## PUBLIC UTILITIES COMMISSION

**RE: Deficiency Report #4 - Certificate of Public Convenience and Necessity for the  
Riverside Transmission Reliability Project – Application No. A.15-04-013**

# DEFICIENCY REPORT #4 FOR THE RIVERSIDE TRANSMISSION RELIABILITY PROJECT APPLICATION (A. 15-04-013)

**CPUC Riverside  
Work Area Constraints  
Mapbook**

Map 1 of 22

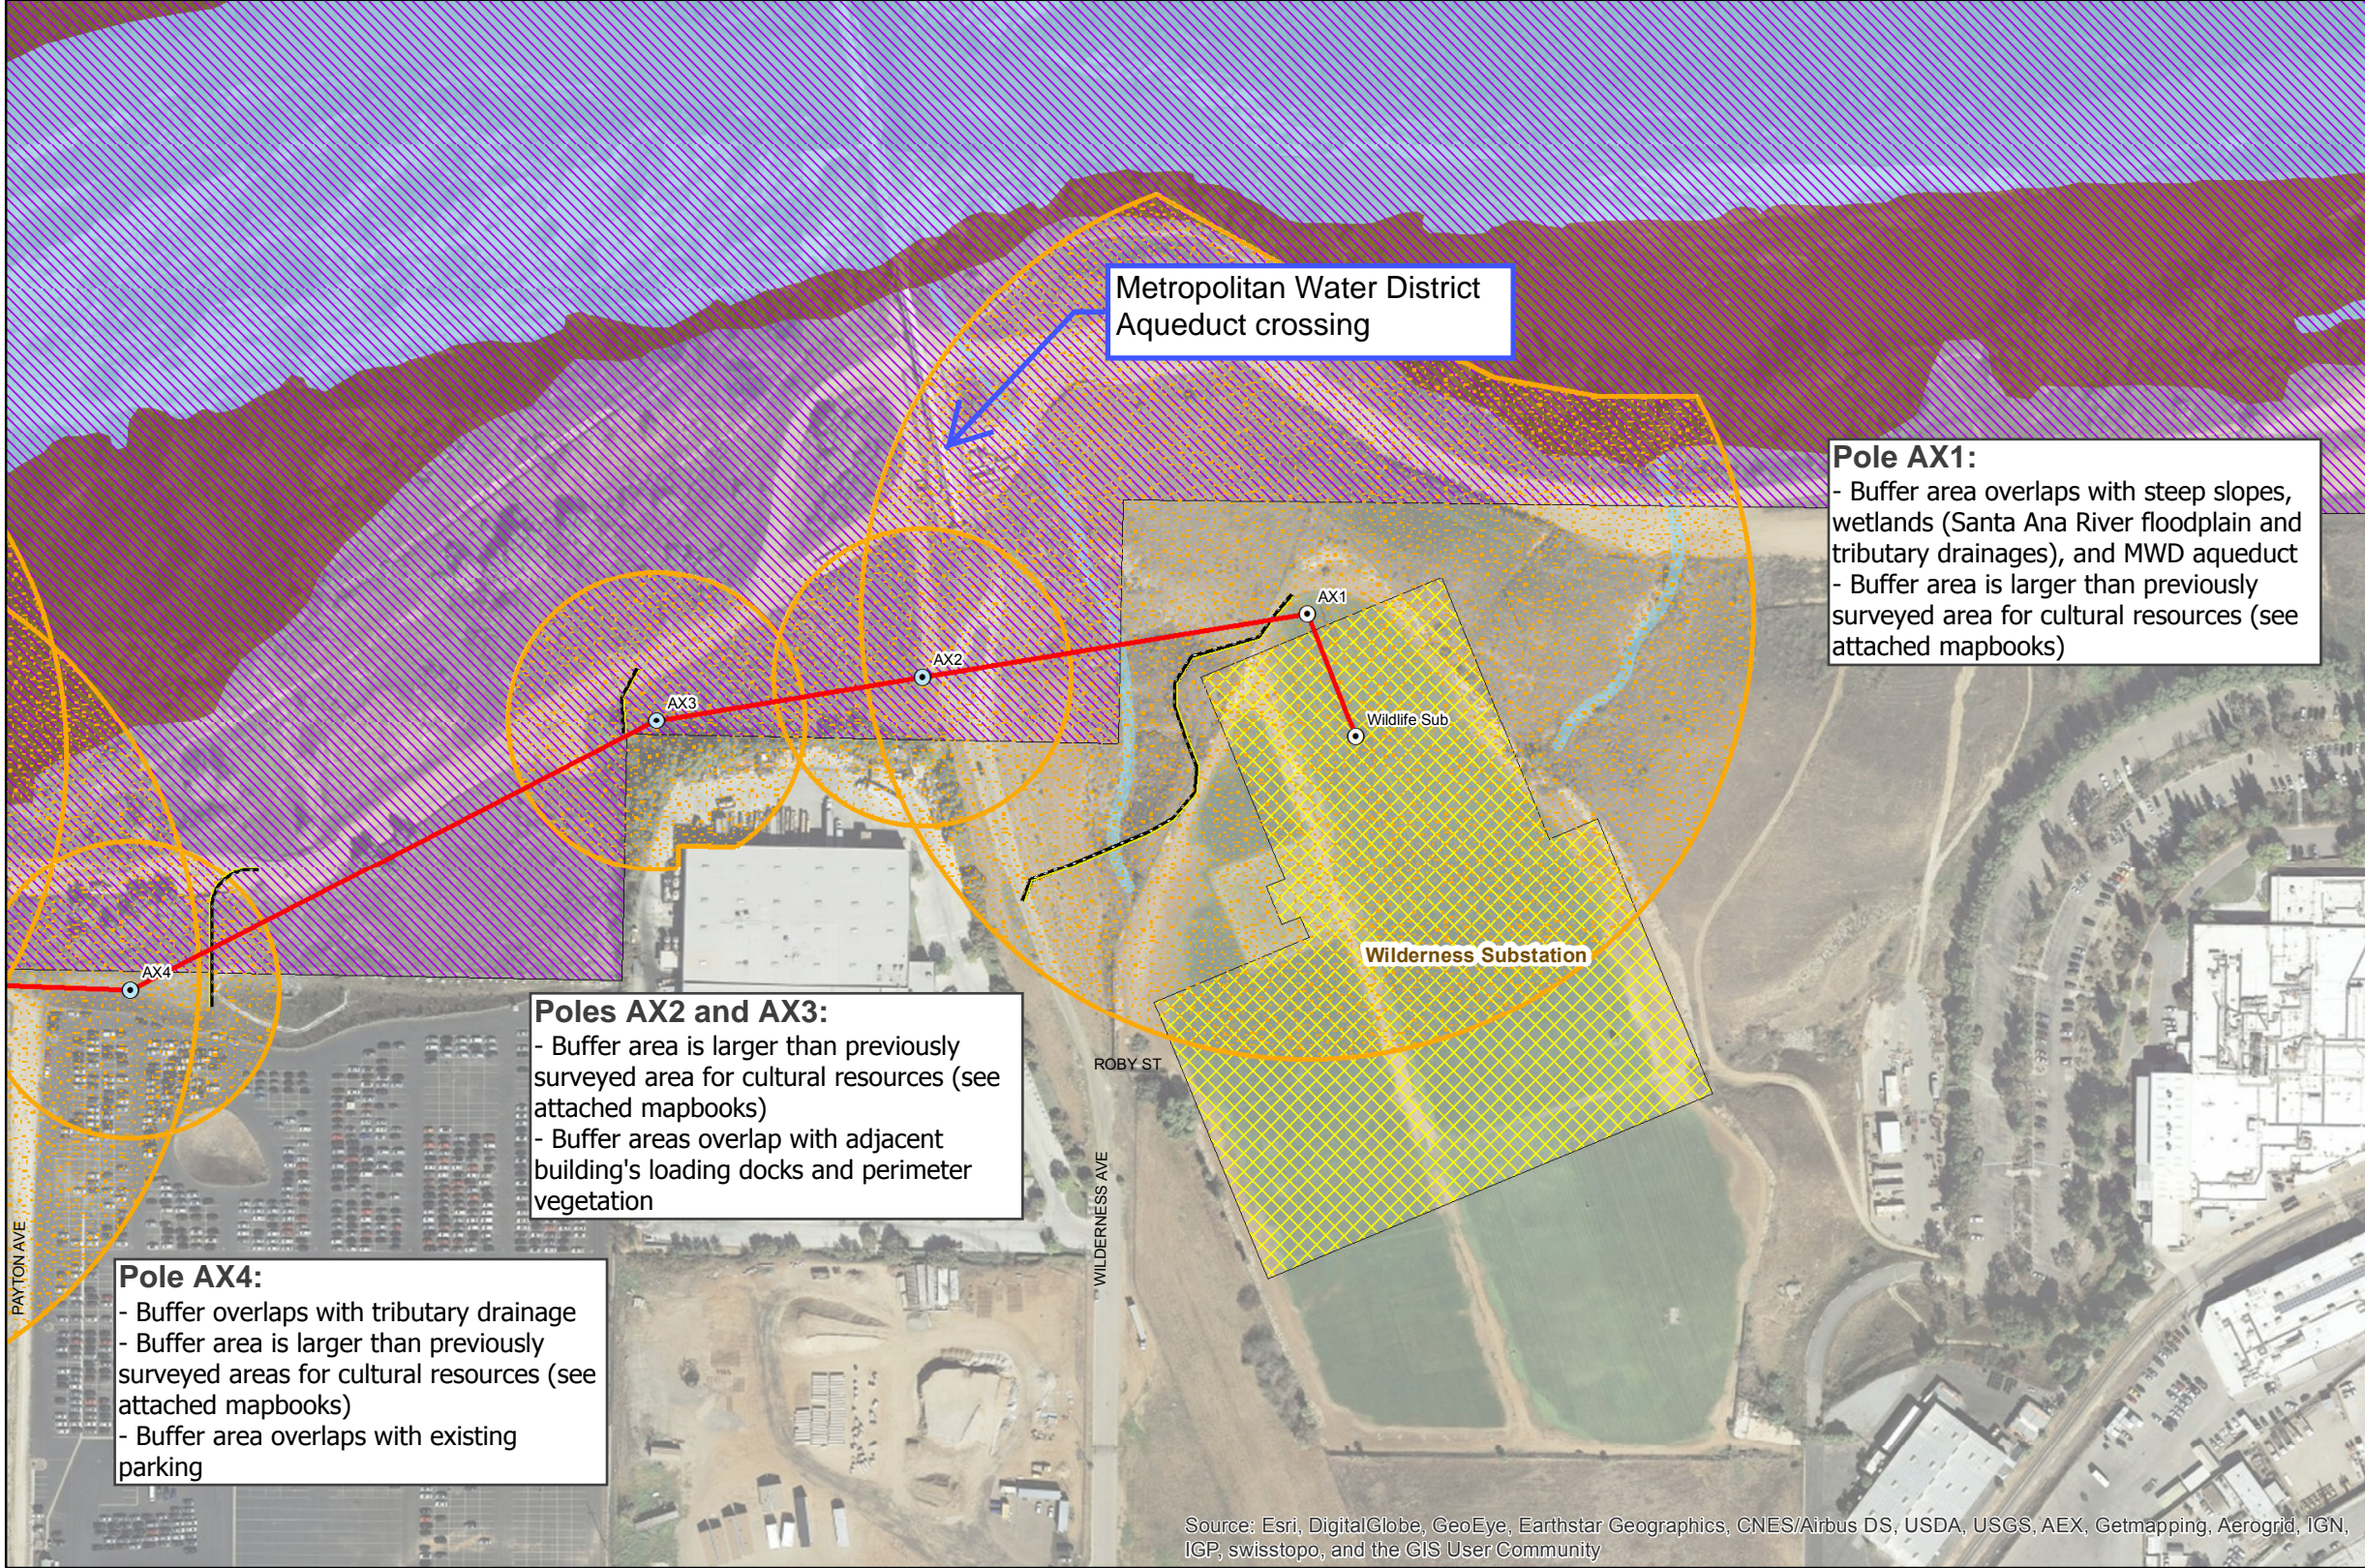
**Pole AX1:**

- Buffer area overlaps with steep slopes, wetlands (Santa Ana River floodplain and tributary drainages), and MWD aqueduct
- Buffer area is larger than previously surveyed area for cultural resources (see attached mapbooks)

**Poles AX2 and AX3:**

- Buffer area is larger than previously surveyed area for cultural resources (see attached mapbooks)
- Buffer areas overlap with adjacent building's loading docks and perimeter vegetation

**Pole AX4:**

- Buffer overlaps with tributary drainage
- Buffer area is larger than previously surveyed areas for cultural resources (see attached mapbooks)
- Buffer area overlaps with existing parking

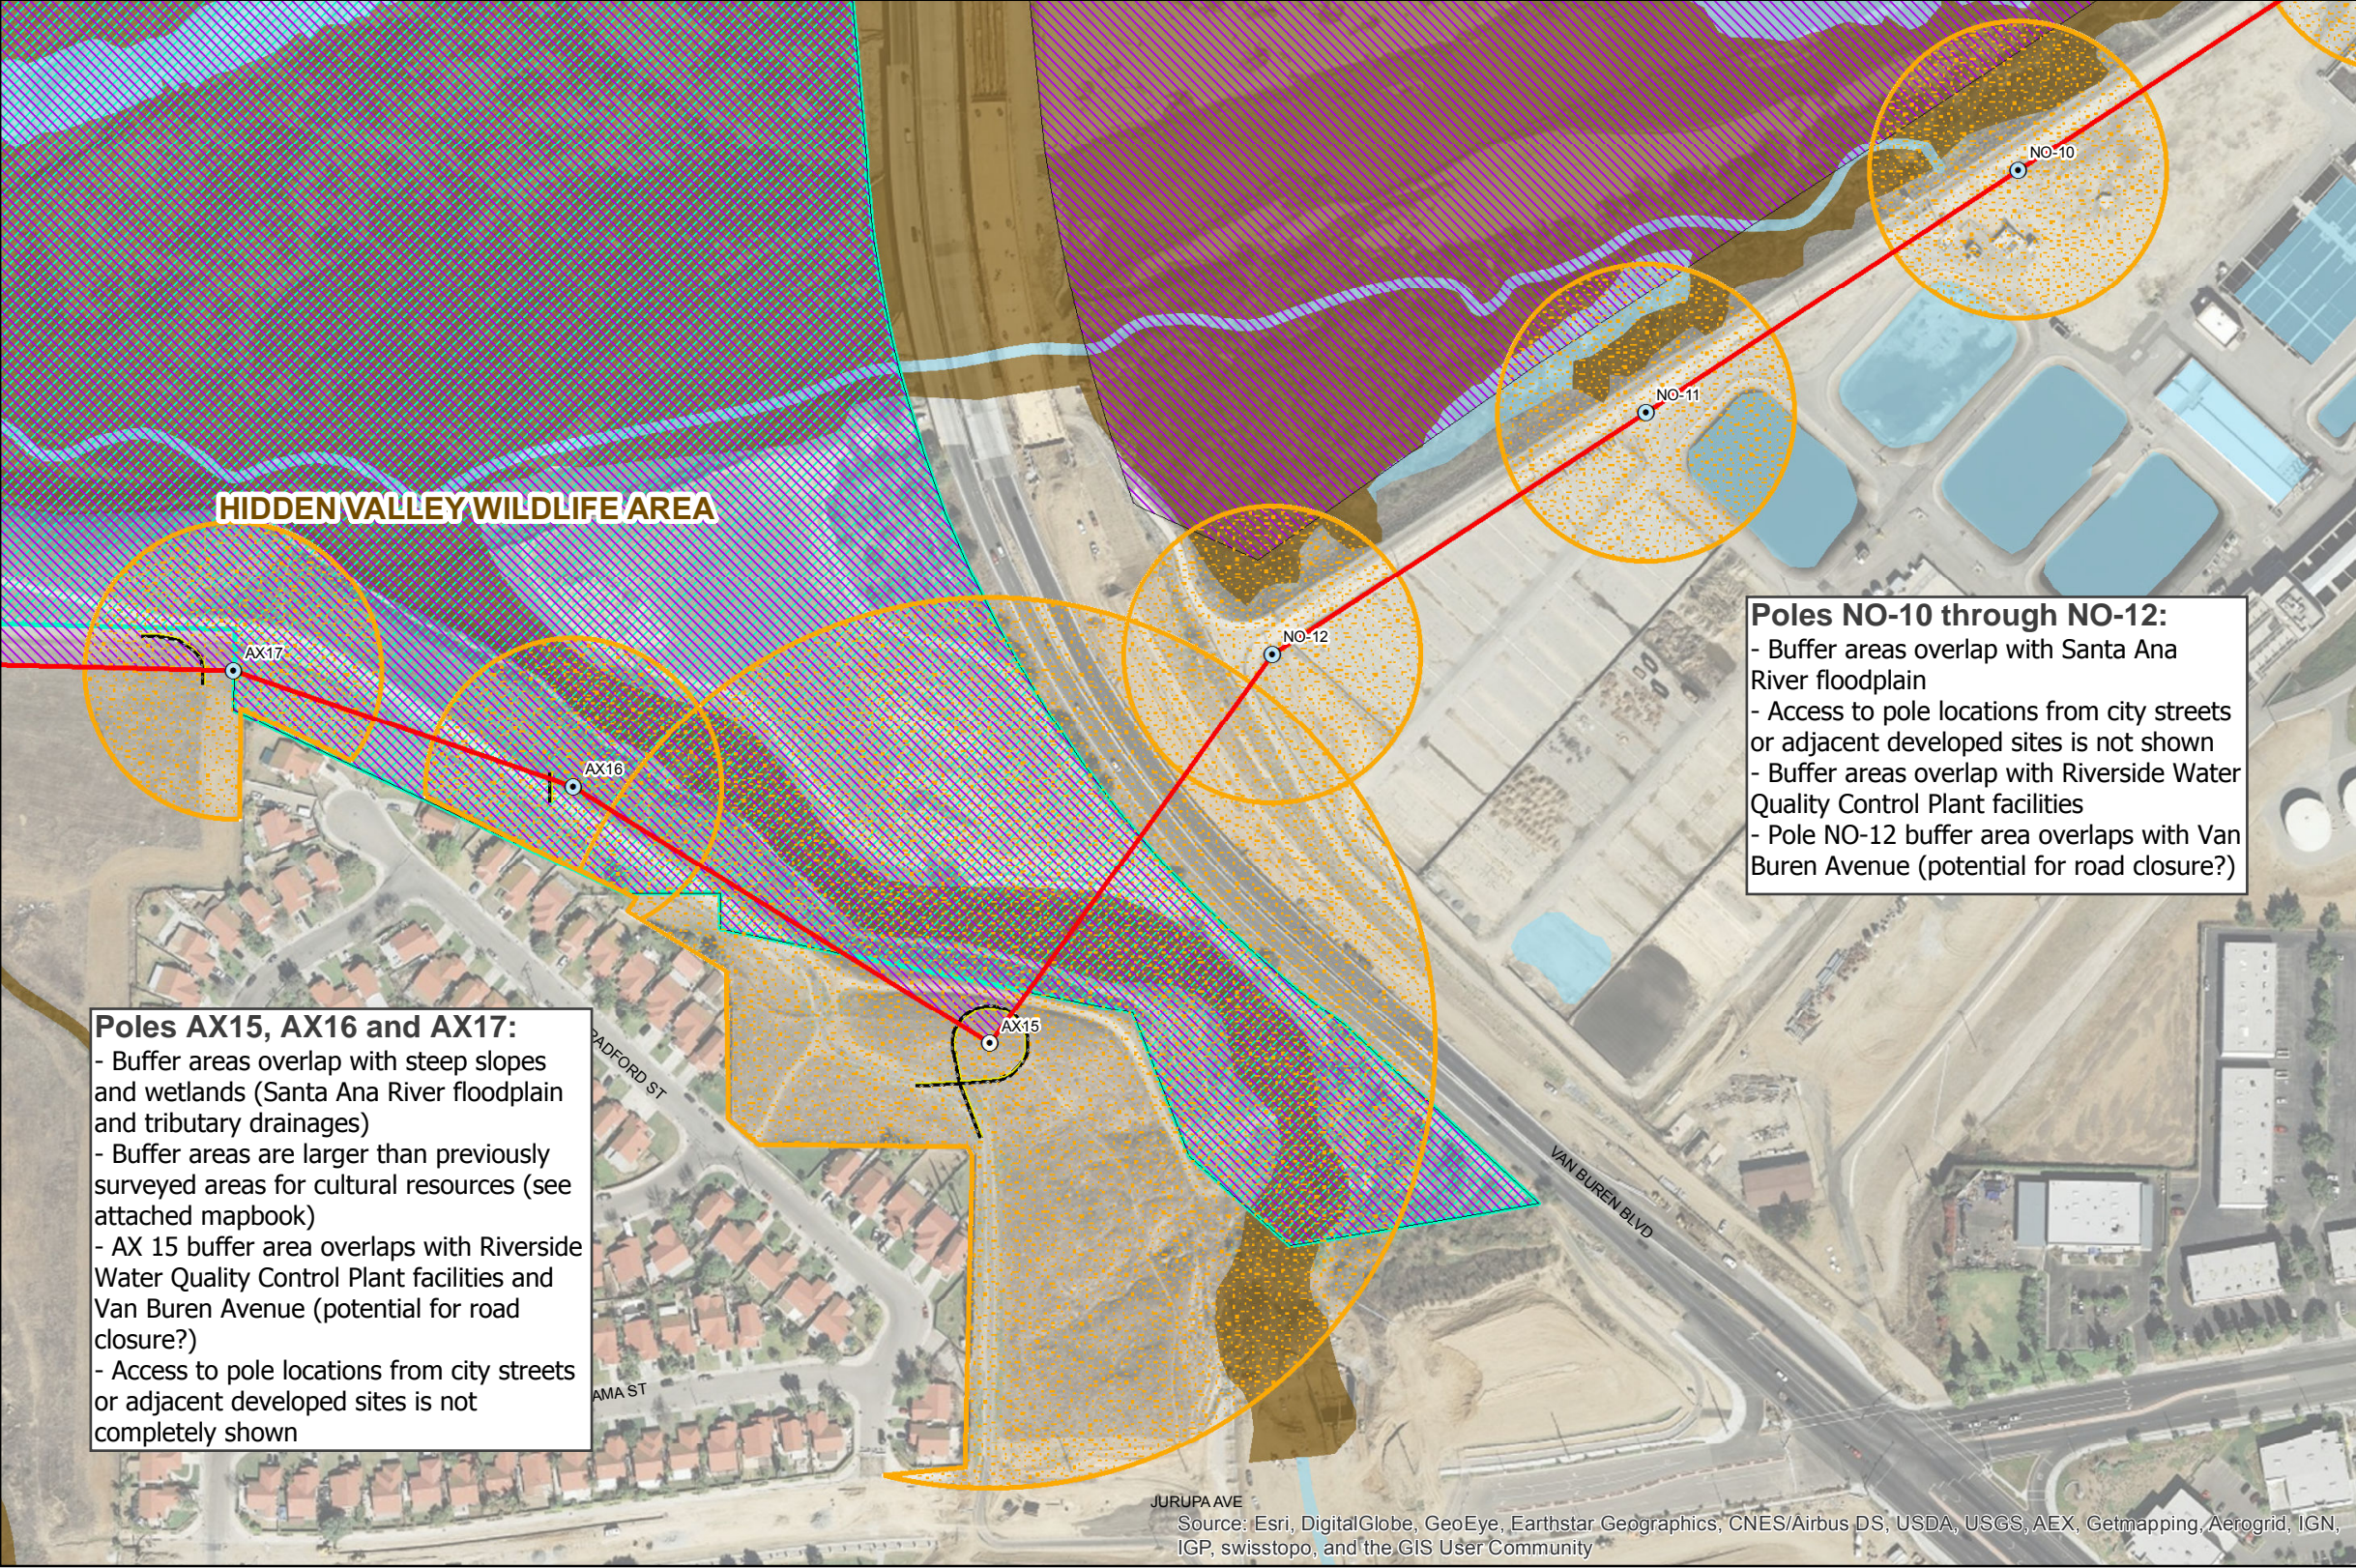
**Poles NO-7 through NO-10:**

- Access to pole locations from city streets or adjacent developed sites is not shown
- Buffer areas are larger than previously surveyed areas for cultural resources (see attached mapbooks)
- Buffer areas overlap with Riverside Water Quality Control Plant facilities

**Poles AX5 and NO-6:**

- Buffer areas overlap with steep slopes and wetlands (Santa Ana River floodplain and tributary drainages)
- Buffer areas are larger than previously surveyed areas for cultural resources (see attached mapbooks)
- Buffer areas overlap with Riverside Water Quality Control Plant facilities
- Access to pole locations from city streets or adjacent developed sites is not shown
- AX5 buffer overlaps with existing parking on the east side of Payton Avenue
